MEMORANDUM

TO:	Laramie County Planning Commission
FROM:	Paul Whalen, AICP, Senior Planner
DATE:	October 22, 2020
TITLE:	Review and action of a Setback Variance Request for the purpose of constructing an accessory structure (garage) at 312 E. Laughlin Road, Laramie County, WY.

PZ-20-00249

Aerial Map

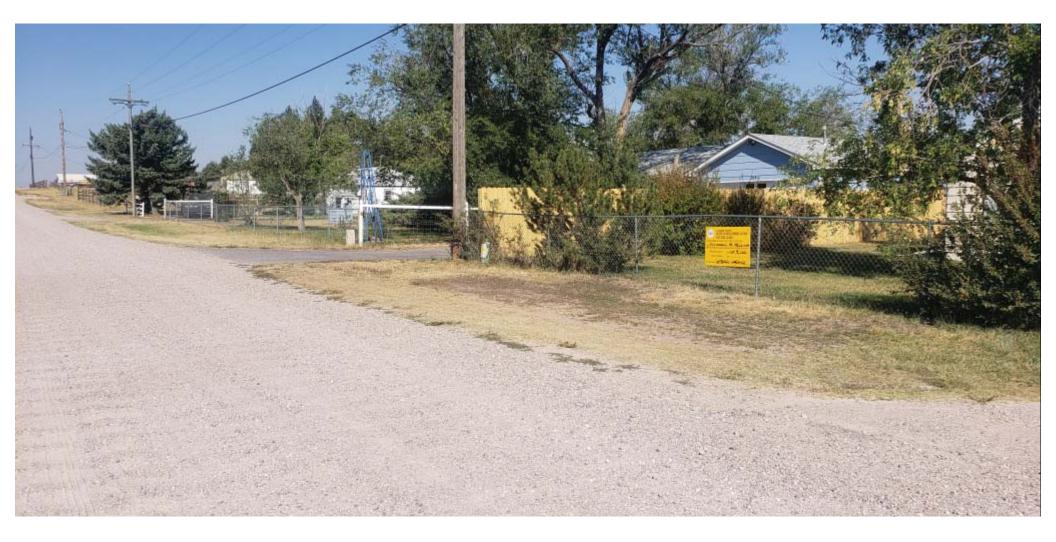
1. Please provide a detailed map or drawing enlargement of the subject area illustrating the lot dimensions/configuration and site features such as leach field/septic tank, house, outbuildings, etc... with the intent the proposed garage pad is the most prudent/suitable location due to hardships. Remember yo are trying to communicate to the Planning Commission, the proposed location is the only location due to hardships-- other features on the site, and the configuration of the lot (narrowness).
